Title	FSB 233-007, Fuel Filter Housing, Replacement; Extra Port On Fuel Filter Housing When Replacing With New Part - Vehicles Manufactured Between 14 November 2016 And 31 December 2019
-------	-------------------------------------------------------------------------------------------------------------------------------------------------------------------------------------------

23393-9 FSB 233-007, Fuel Filter Housing, Replacement

(April 2020)

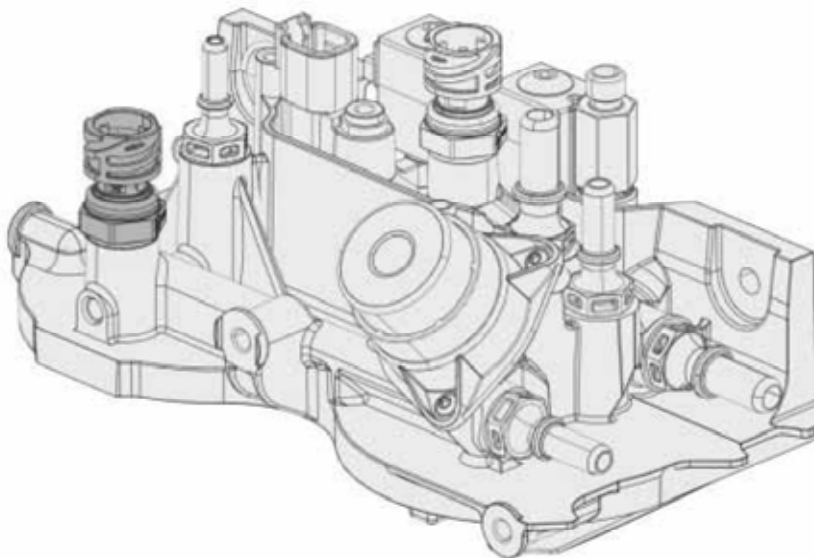
All Volvo vehicles built with 11L or 13L engines, between 11/14/2016 and 12/31/2019, that need to have the fuel filter housing replaced, will get superseded to a new part that will require the installation of a plug in the second sensor port.

The superseded fuel filter housing will contain a port for a second fuel pressure sensor.

On trucks built before 1/1/2020, the software does not support the functionality of this new sensor.

Note: If the fuel filter housing is replaced with any of the following part numbers, follow the steps in this bulletin to correctly block the sensor port.

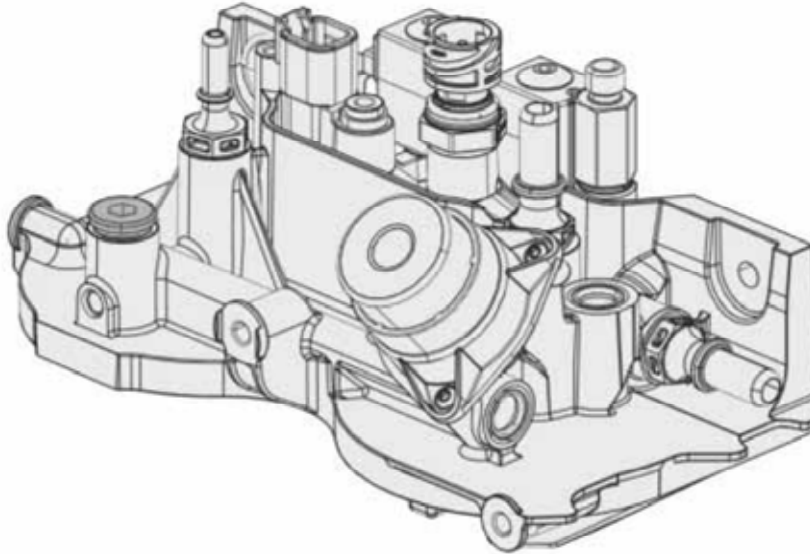
1. Remove the fuel pressure sensor from the secondary fuel pressure sensor port.

2. Install the plug into secondary fuel pressure sensor port.

Tightening torque	
Plug, secondary fuel pressure sensor port (M16)	25±3 Nm (18.66 ft,lbs)
